Bethesda Downtown Design Advisory Panel DAP Response Narrative

Project: 7025-7039 Strathmore Street

DATE: May 14, 2025

FIRST FLOOR PLAN

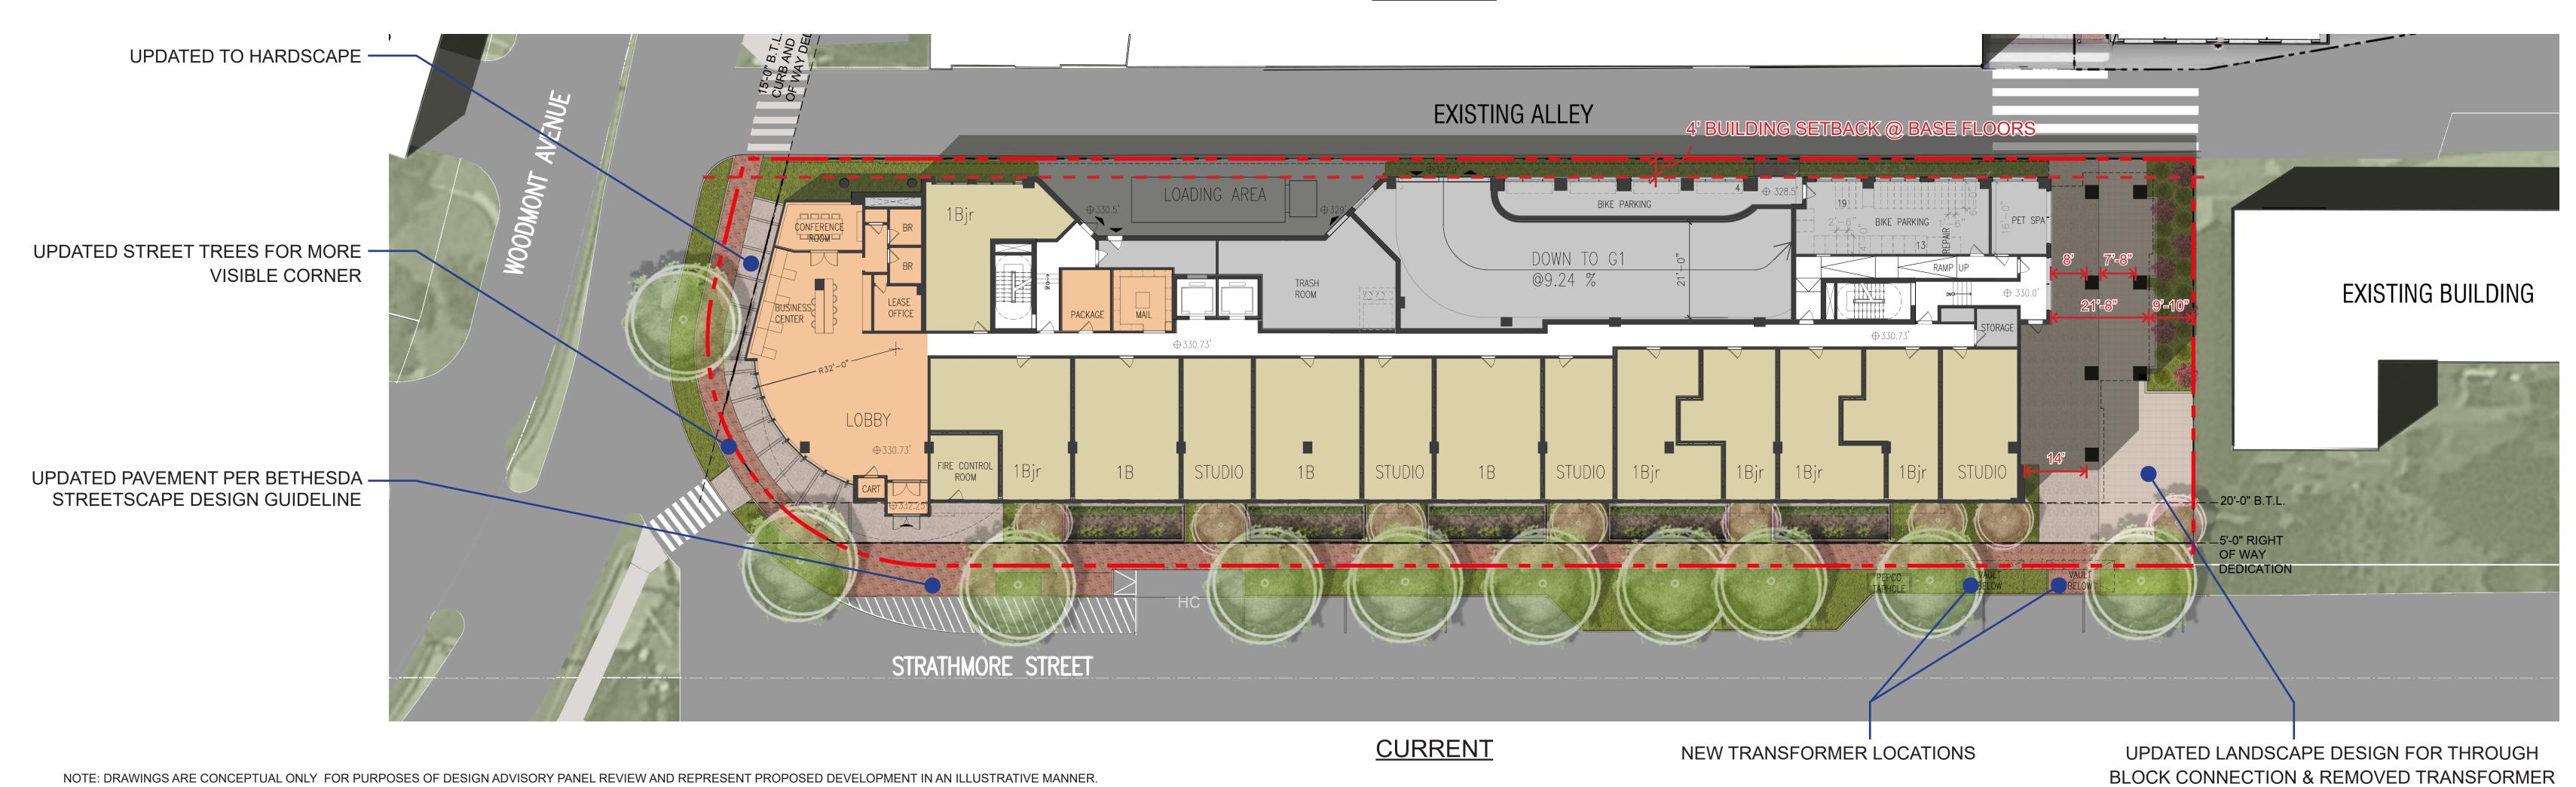
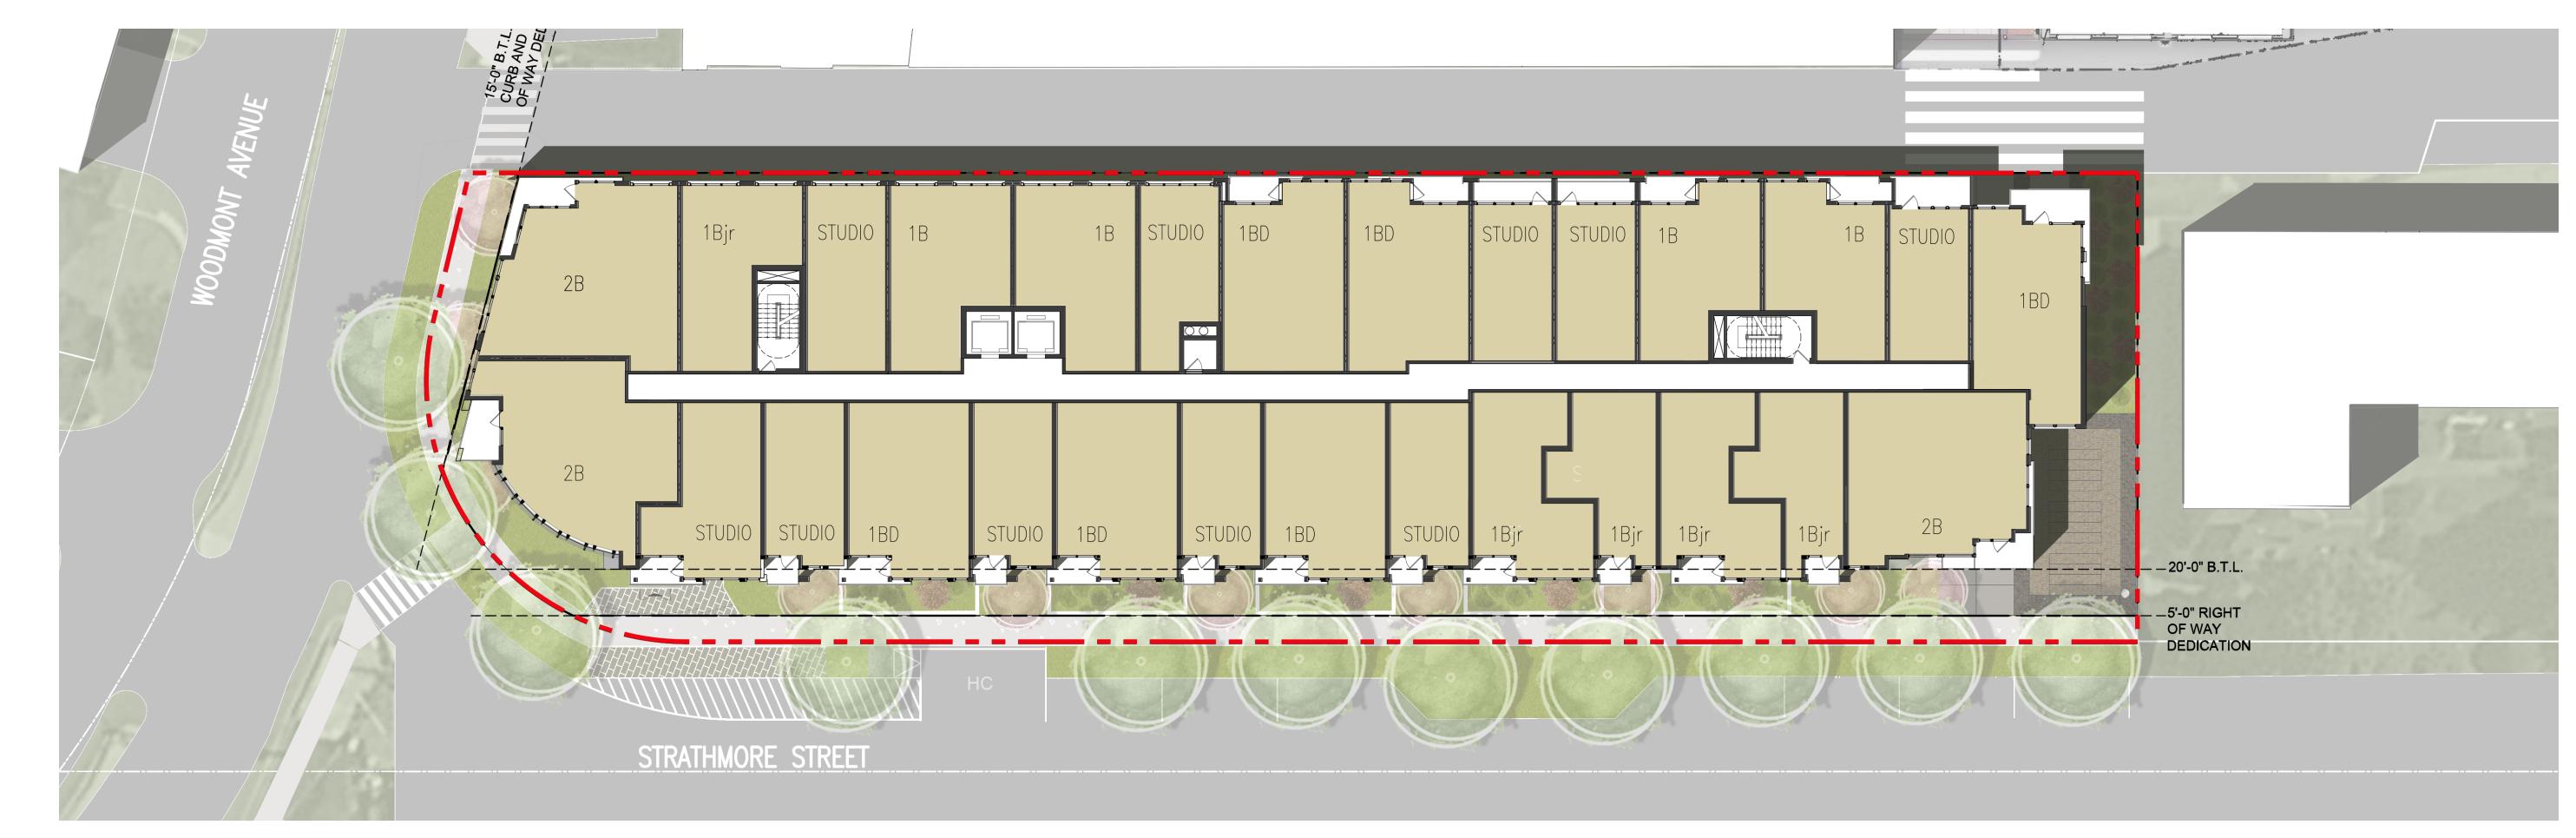
- 1. Update of the ground floor layout to show sidewalk material at the corner of the building and removal of plantings.
 - Hardscape has been added at the corner as per the panel's recommendation, replacing the previous plantings.

PERSPECTIVE RENDERING

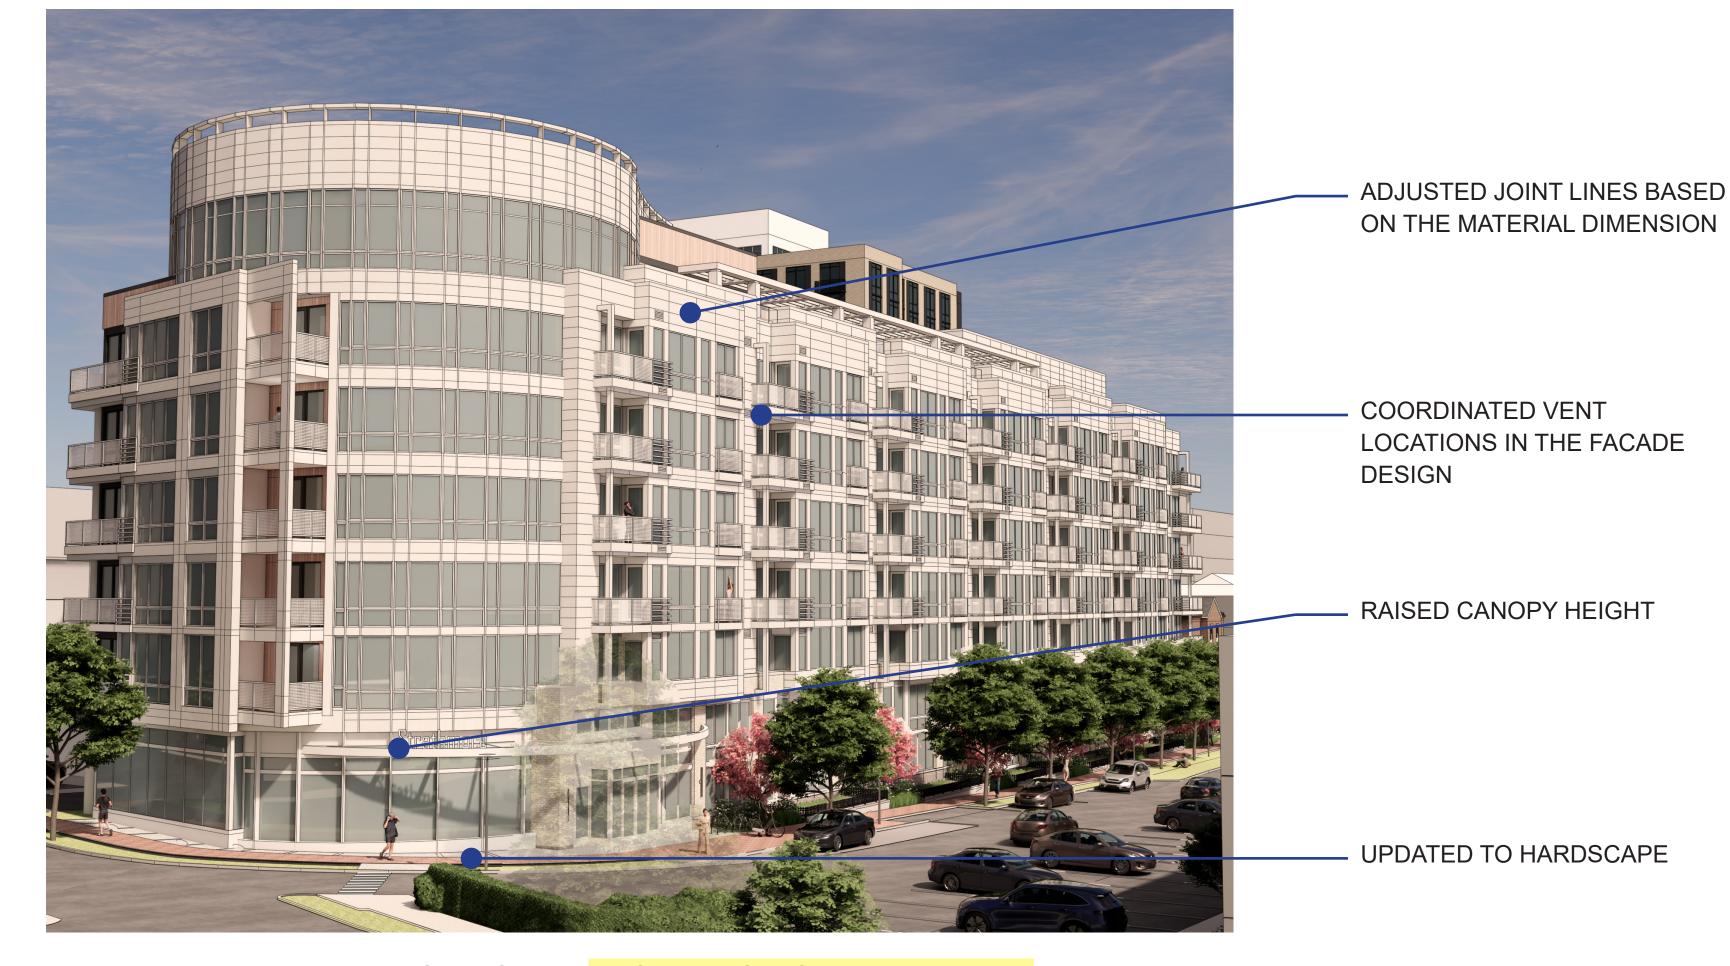
COORDINATED GARAGE VENT LOCATION

PERSPECTIVE RENDERING

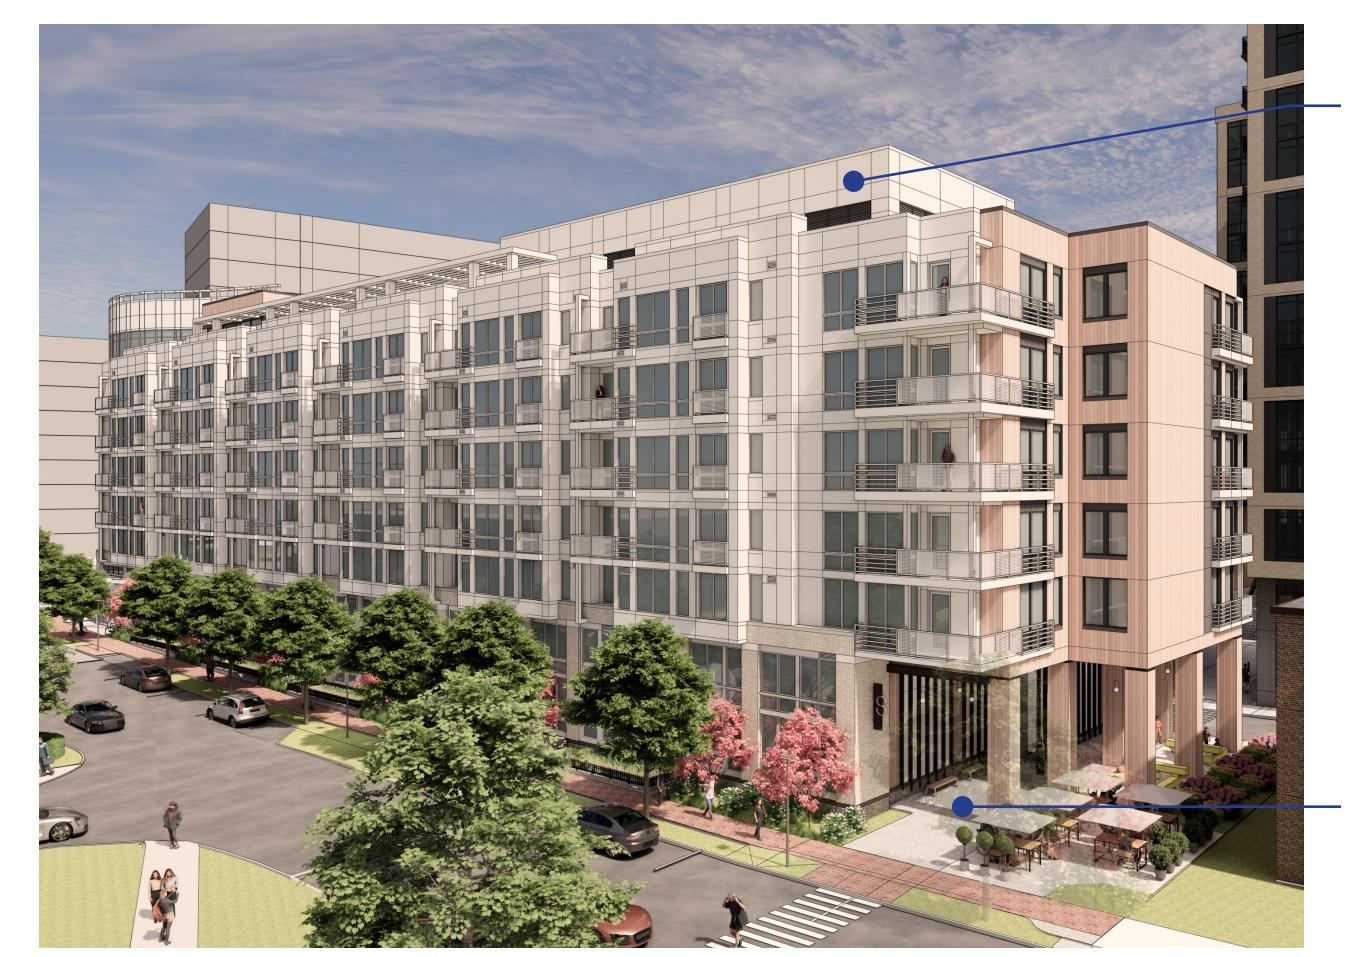
UPDATED LANDSCAPE DESIGN FOR THROUGH BLOCK CONNECTION

ADJUSTED JOINT LINES BASED
 ON THE MATERIAL DIMENSION
